HISTORIC AND DESIGN REVIEW COMMISSION

HDRC CASE NO: 2022-146
ADDRESS: 820 NOLAN ST
LEGAL DESCRIPTION: NCB 563 BLK 7 LOT 4
ZONING: R-6, H
CITY COUNCIL DIST.: 2
DISTRICT: Dignowity Hill Historic District
APPLICANT: Eric Estopinal/WALNUT COMPANY INVESTMENTS LLC
OWNER: Eric Estopinal/WALNUT COMPANY INVESTMENTS LLC
TYPE OF WORK: Amendment to a previously approved design regarding window replacement
APPLICATION RECEIVED: February 15, 2022
60-DAY REVIEW: Not applicable due to City Council Emergency Orders
CASE MANAGER: Edward Hall

The applicant is requesting a Certificate of Appropriateness for approval to amend the previously approved window profile for replacement windows at 820 Nolan Street, located within the Dignowity Hill Historic District.

WINDOW SCHEDULE

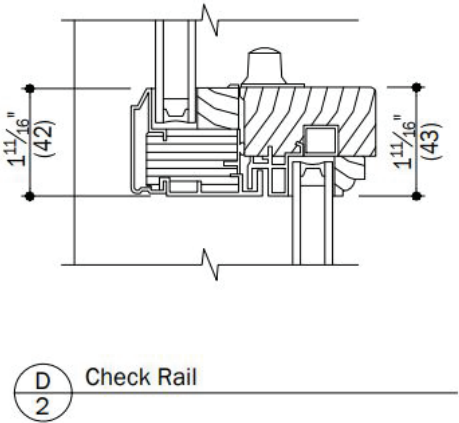
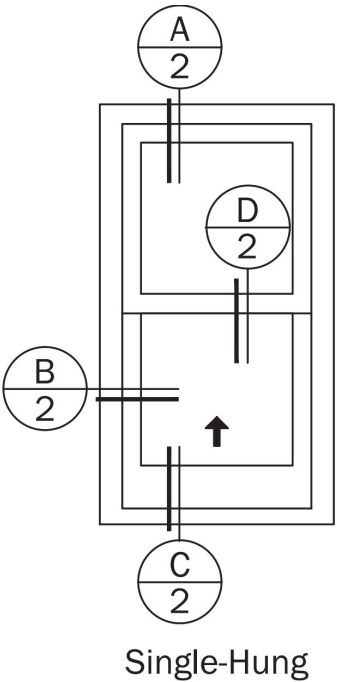
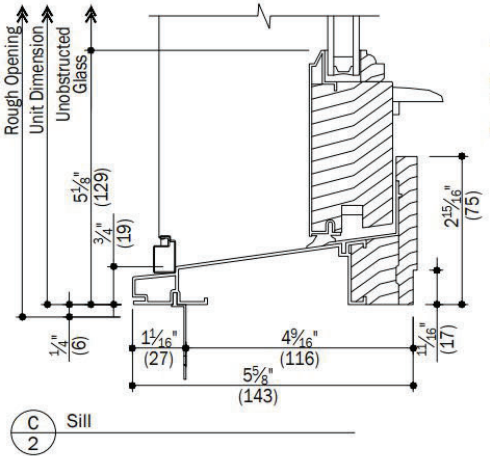
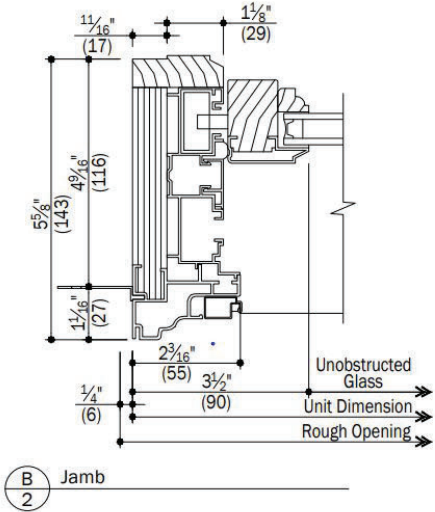
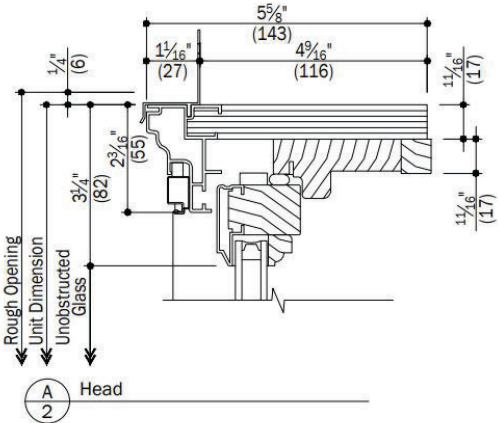
- c. **CURRENT REQUEST** – The applicant has noted the inability to find a two over two window that meet staff's standards for windows in new construction. The applicant has proposed to use baffles/faux divided lites to accomplish a two over two profile.

- d. **STANDARD SPECIFICATIONS** – OHP staff's standard specifications for replacement windows notes that faux divided lites and internal grilles should not be used in replacement windows. Staff finds the proposed use of any faux divided lite element to be inappropriate and inconsistent with both staff's standards and the Guidelines.

Staff recommends the applicant install wood or aluminum clad wood windows that are consistent with staff's standards for replacement windows. Additionally, recommends the applicant explore the installation of salvaged two over two wood windows.
